ADDENDUM NO. 2

July 29, 2026

The Solanco Area School District | New District Administration Offices & Turf Fields
CRA Project No. 3706

GRINDER PUMP DETAIL

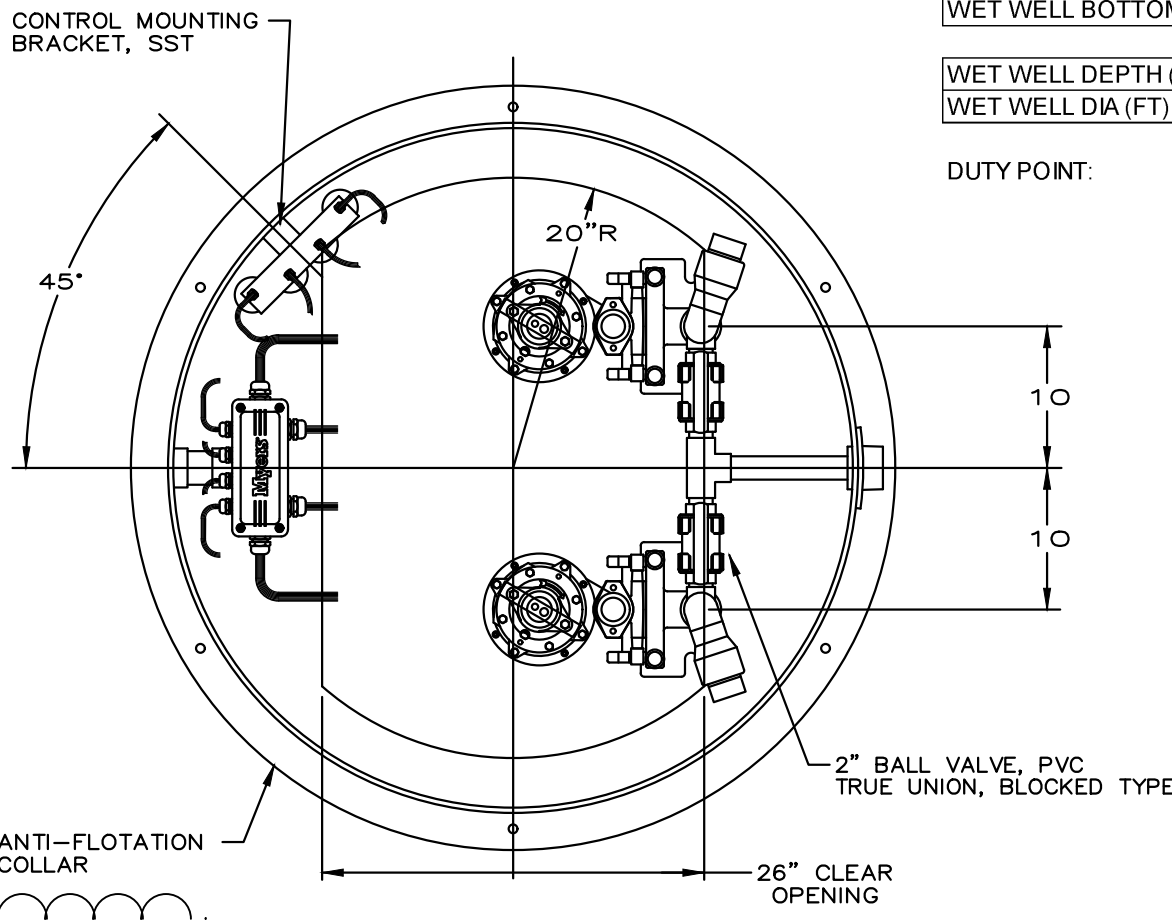
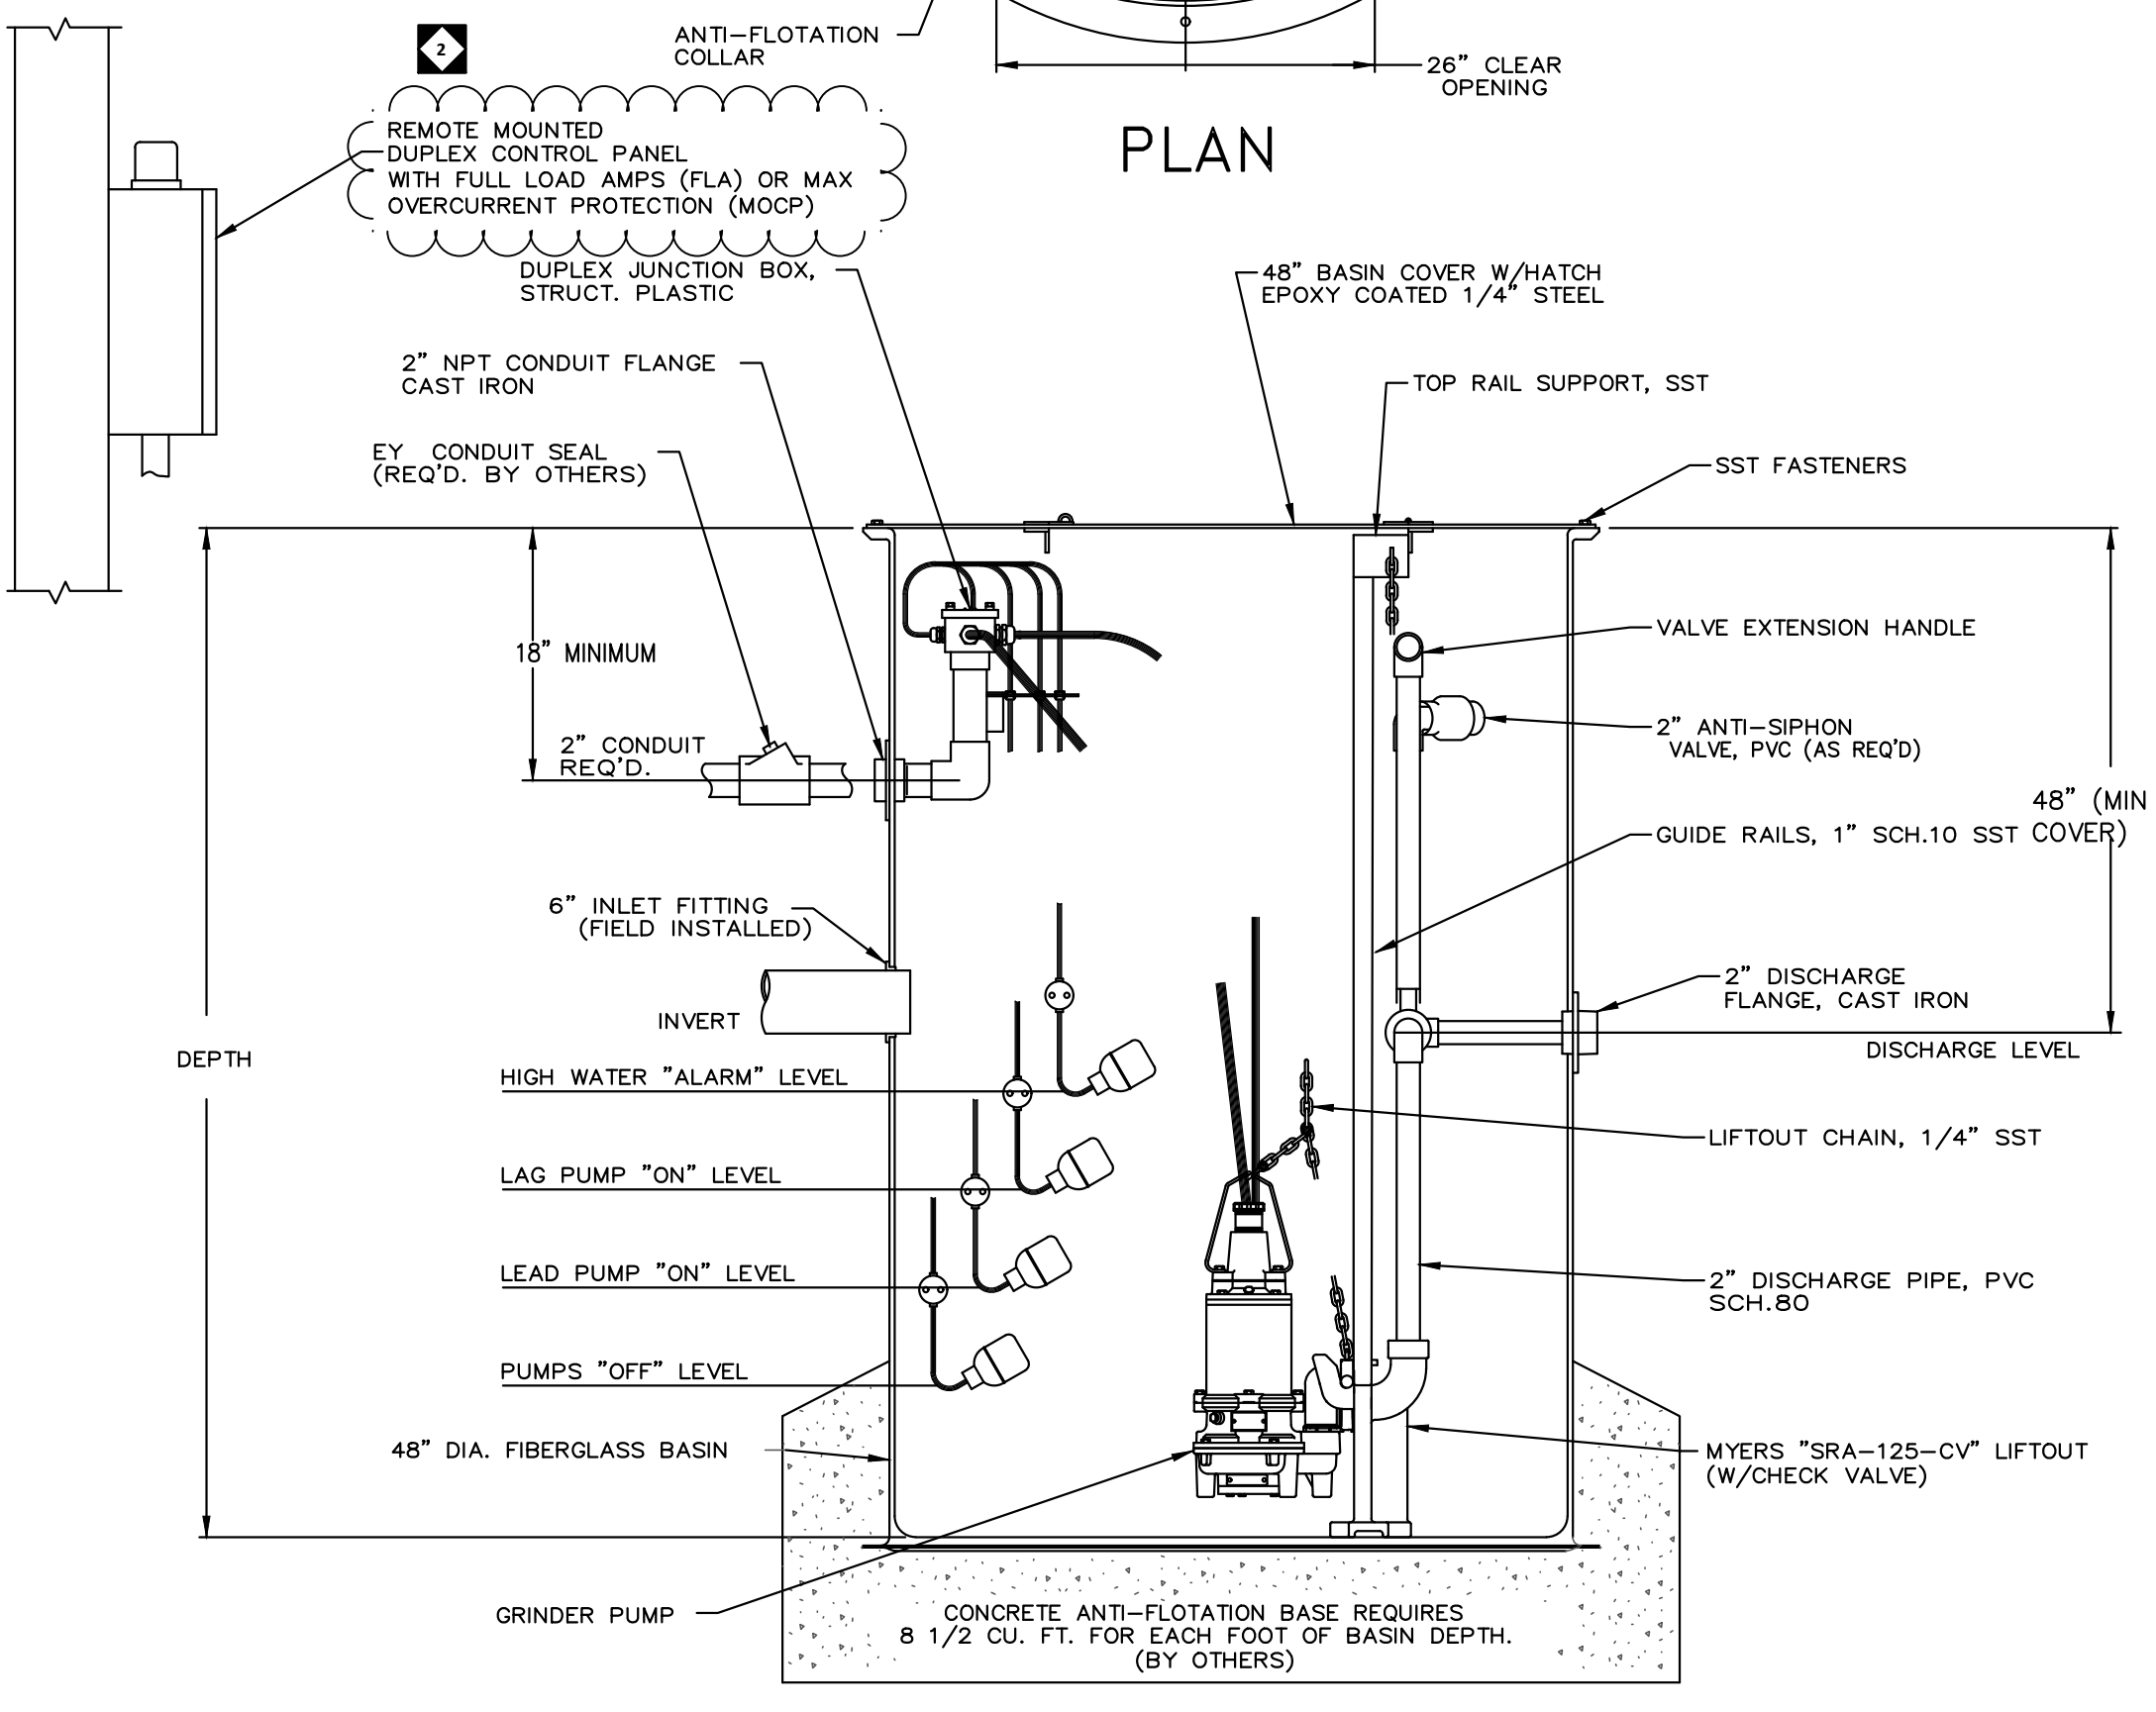
DRAWING C-603– DETAILS

1. **REVISED** the Grinder Pump detail.

C604

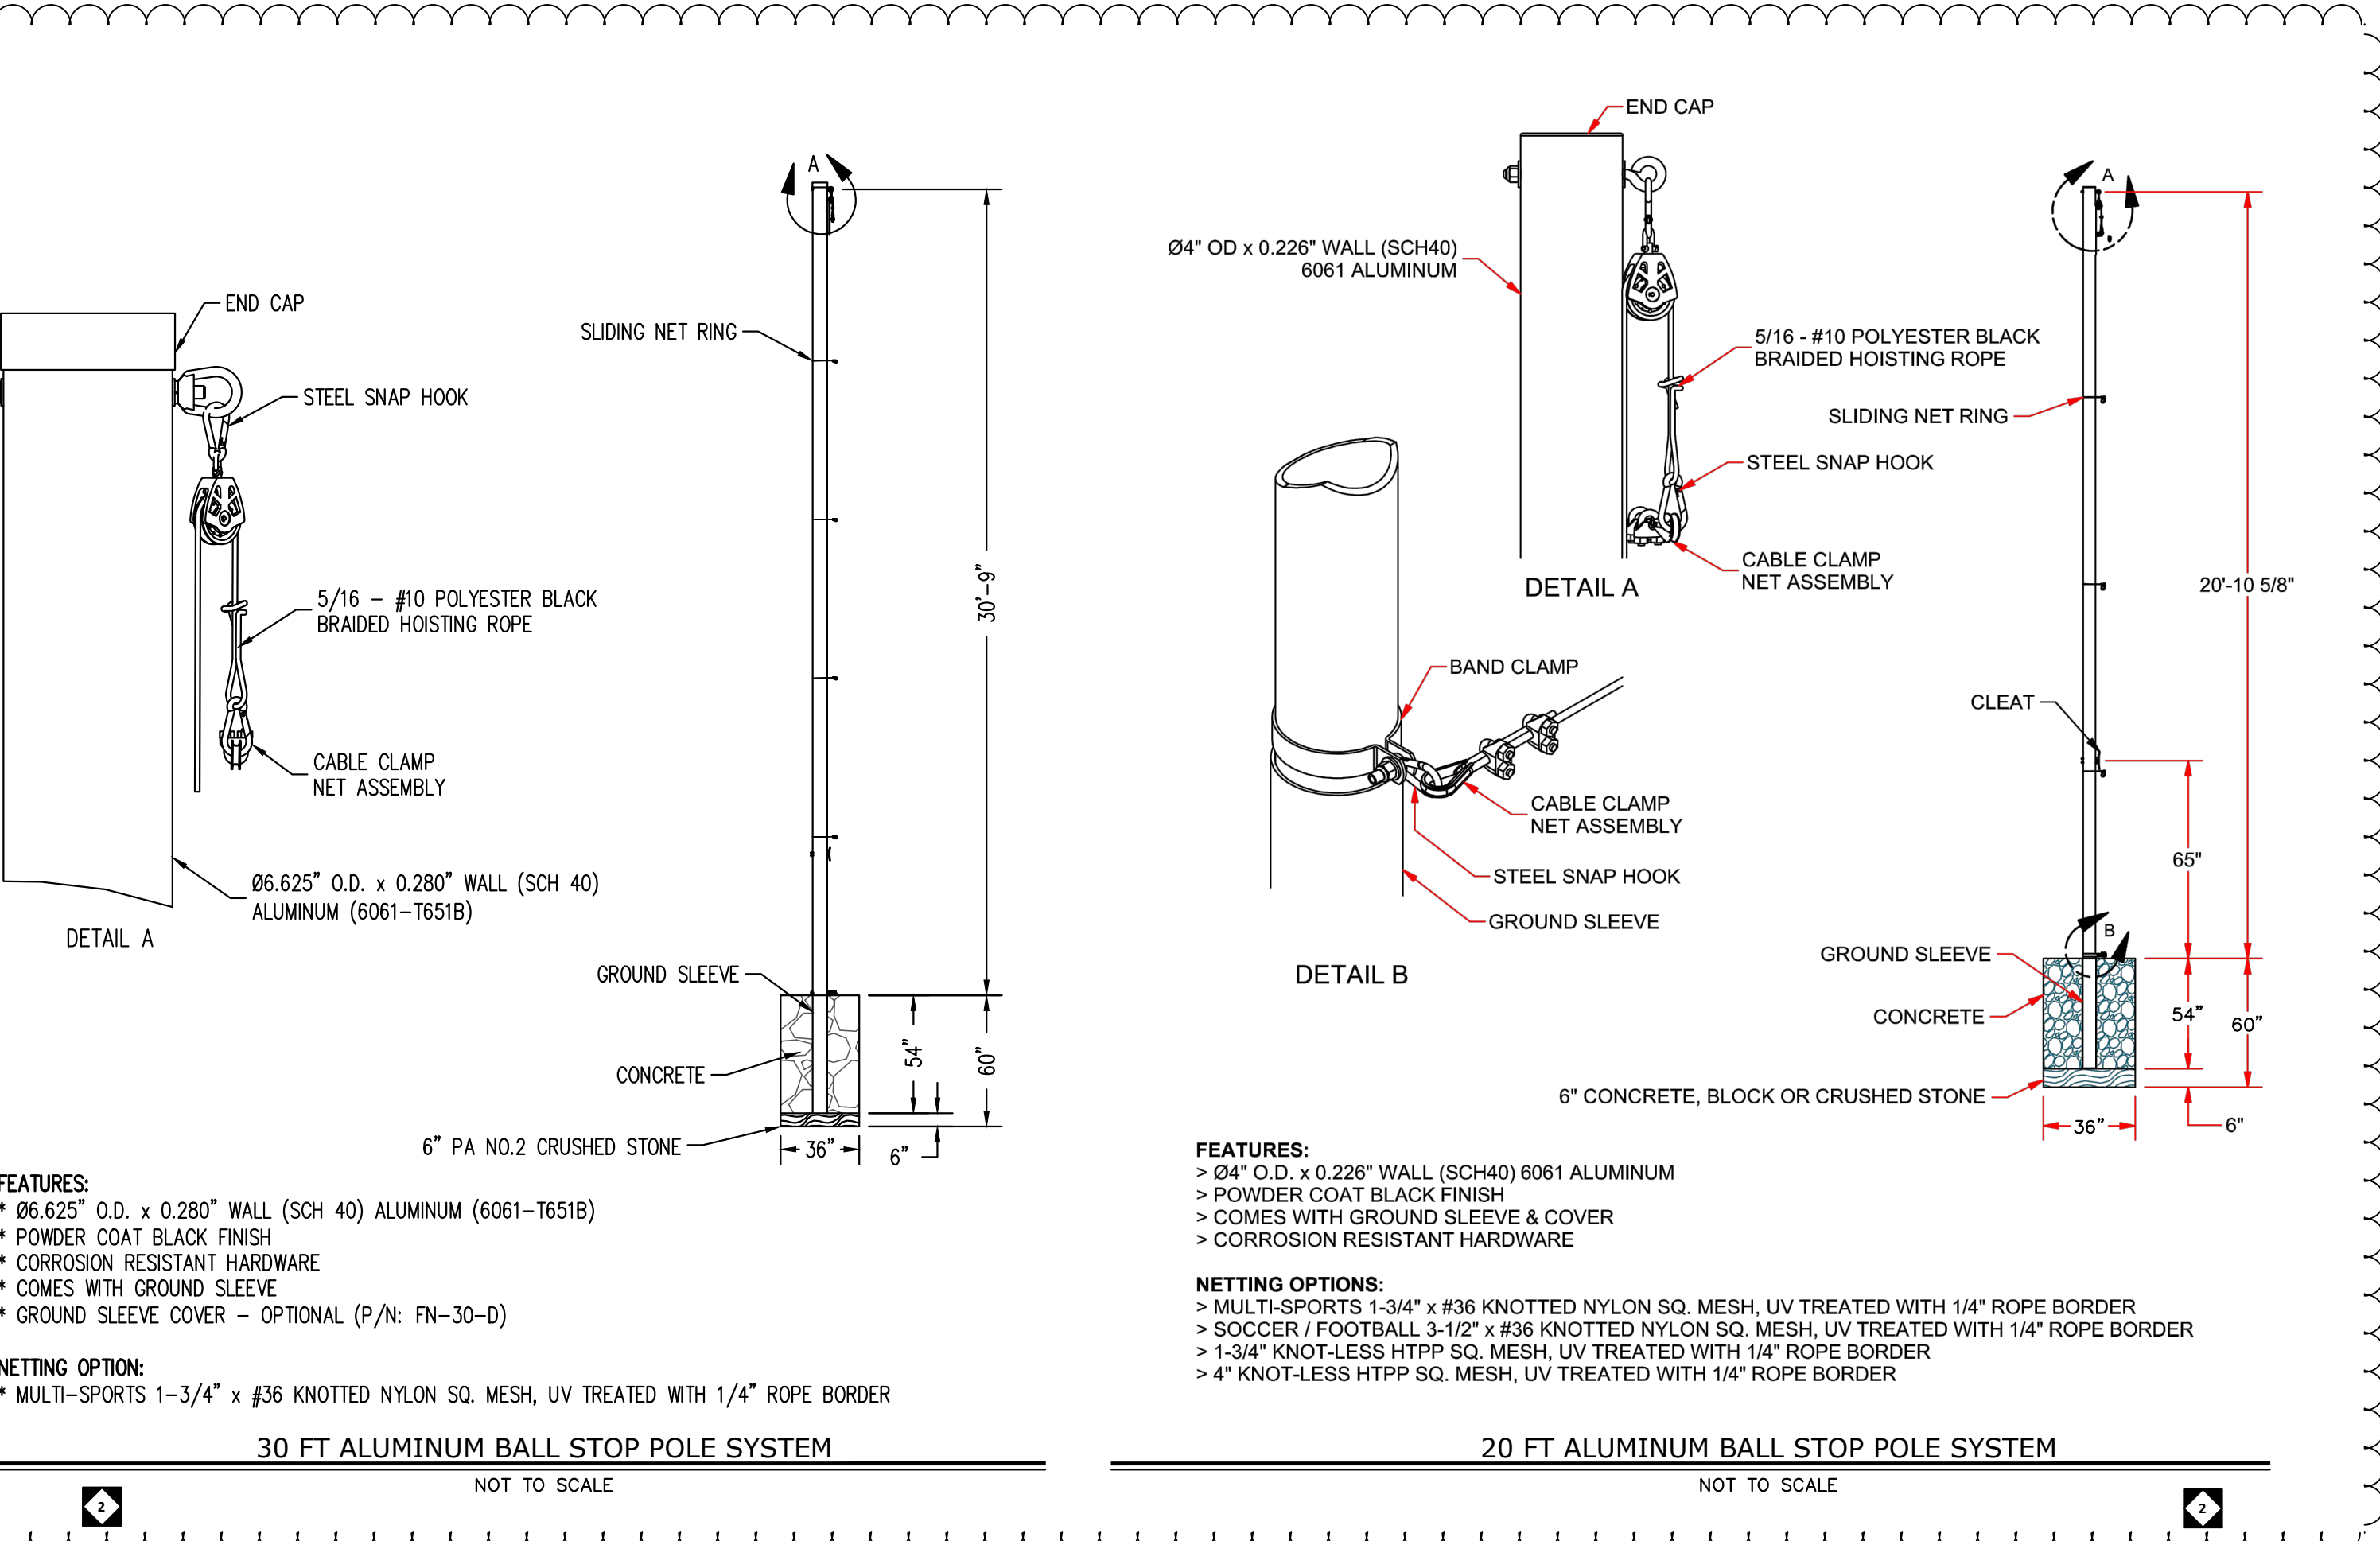
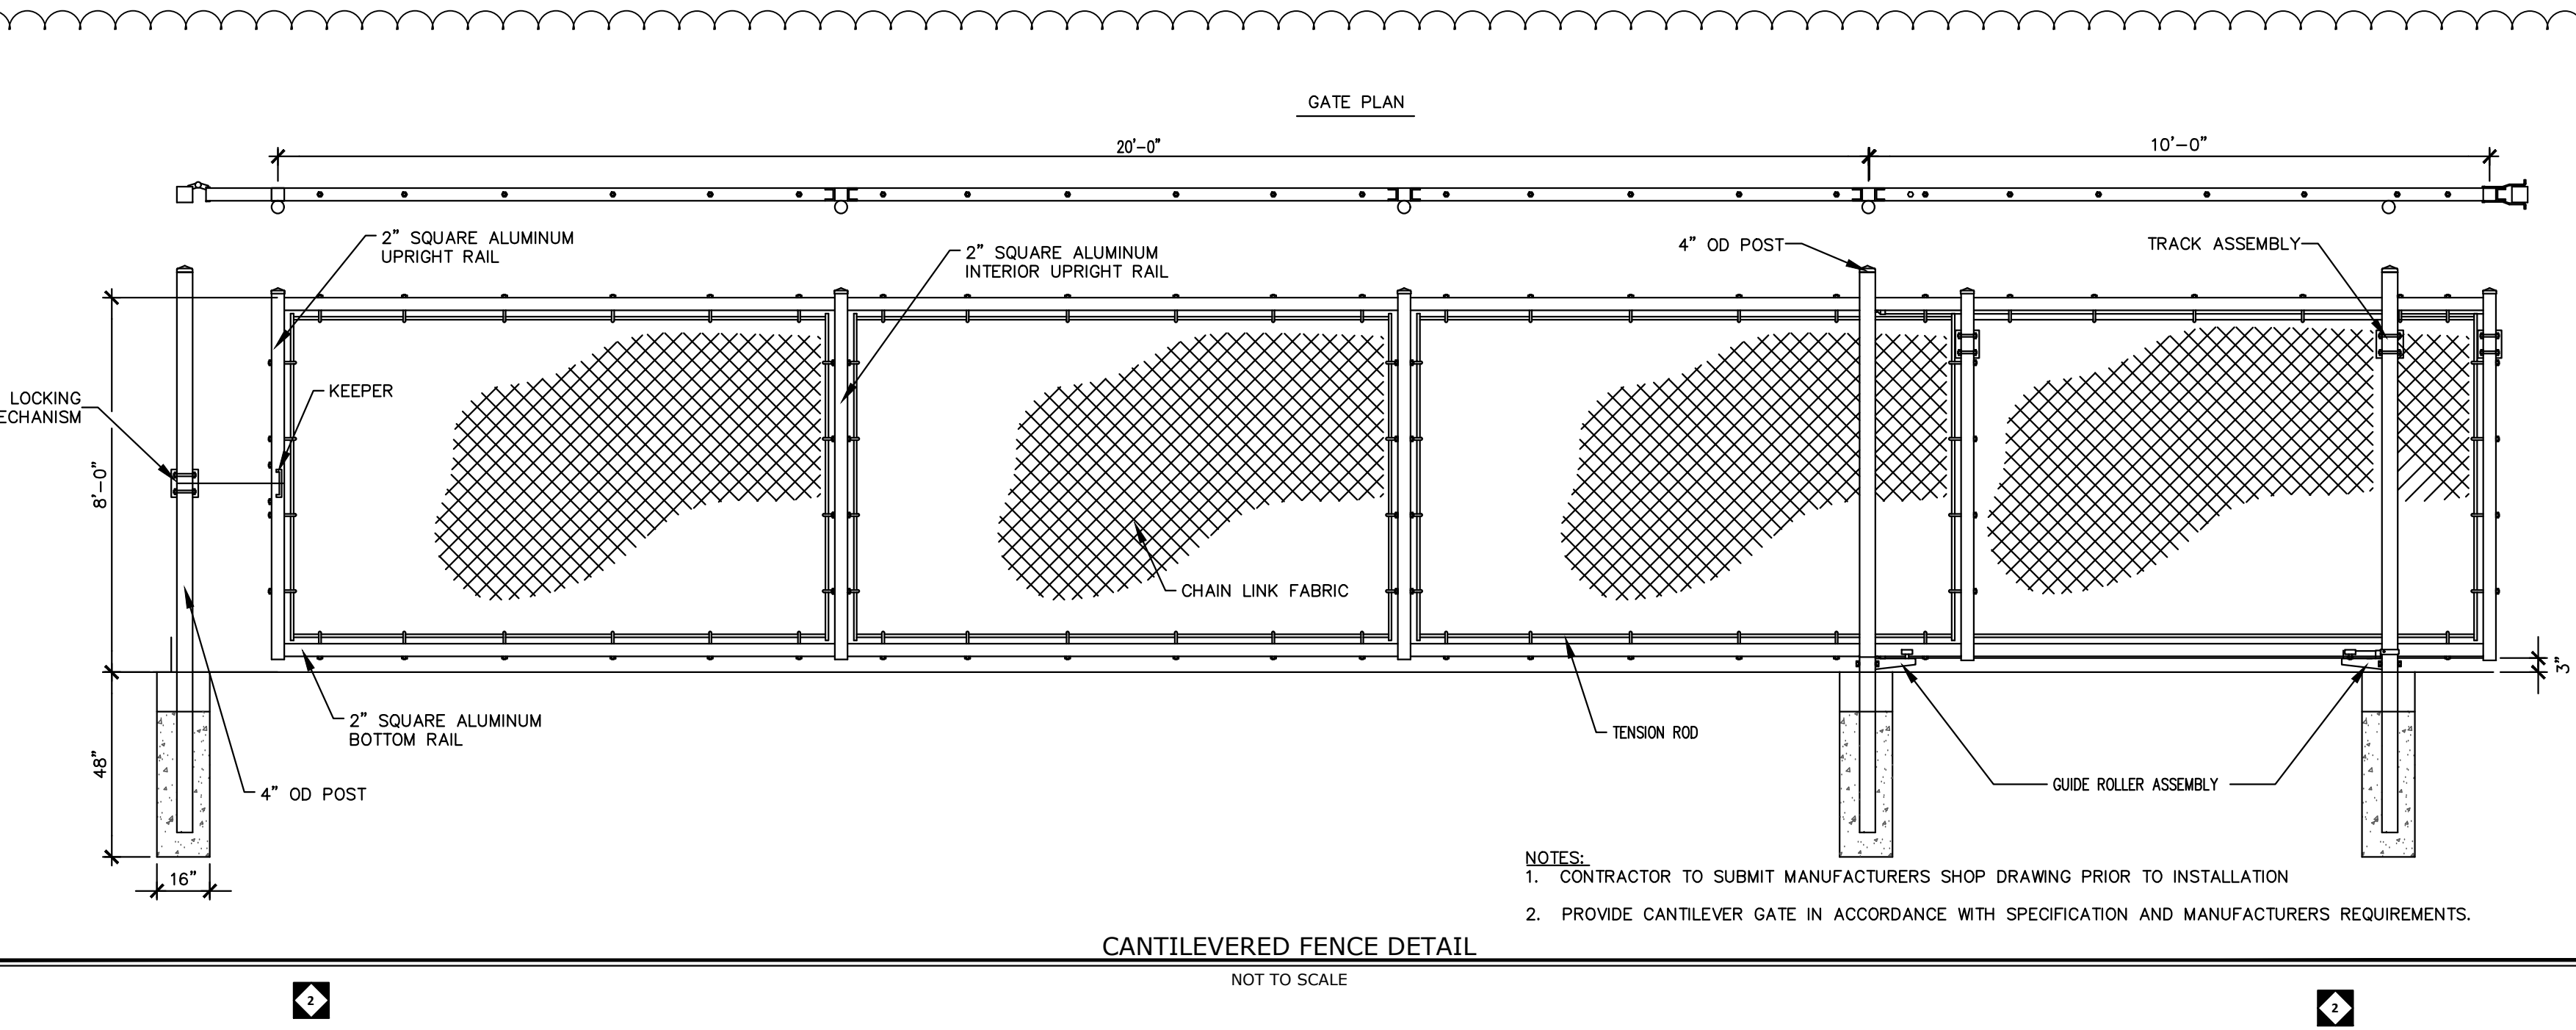
DRAWING C-604– DETAILS

1. **REVISED** the detail name to “PERIMETER TURF CURB WITH INTEGRAL FENCE”.
